#### HISTORIC AND DESIGN REVIEW COMMISSION

HDRC CASE NO: COMMON NAME: ZONING:	<b>2015-213</b> Martinez Creek Trail - 653 Cincinnati UZROW
CITY COUNCIL DIST.:	1
APPLICANT:	Marc Zac/Terra Design Group
OWNER:	COSA
TYPE OF WORK:	Park Improvements

# MARTINEZ CREEK TRAIL

### CITY OF SAN ANTONIO OFFICE OF HISTORIC PRESERVATION HISTORIC AND DESIGN REVIEW COMMISSION: SUPPORTING MATERIALS

# SITE PLAN

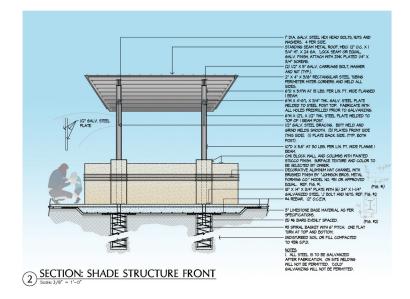
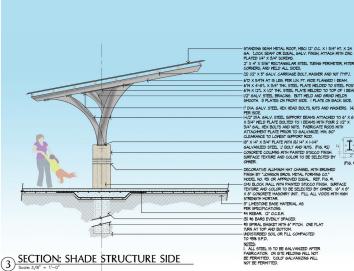
- b. The proposed walkways and trails are appropriate for their location and will improve accessibility to the park. This is consistent with the UDC Section 35-642.a.3.
- c. The proposed installation of public amenities including trash cans, seating and signage appear to be compatible with the landscape. This is consistent with the UDC section 35-642.b. 8.
- d. The project has been reviewed by the City Archaeologist.

Staff recommends approval based on items a through d.
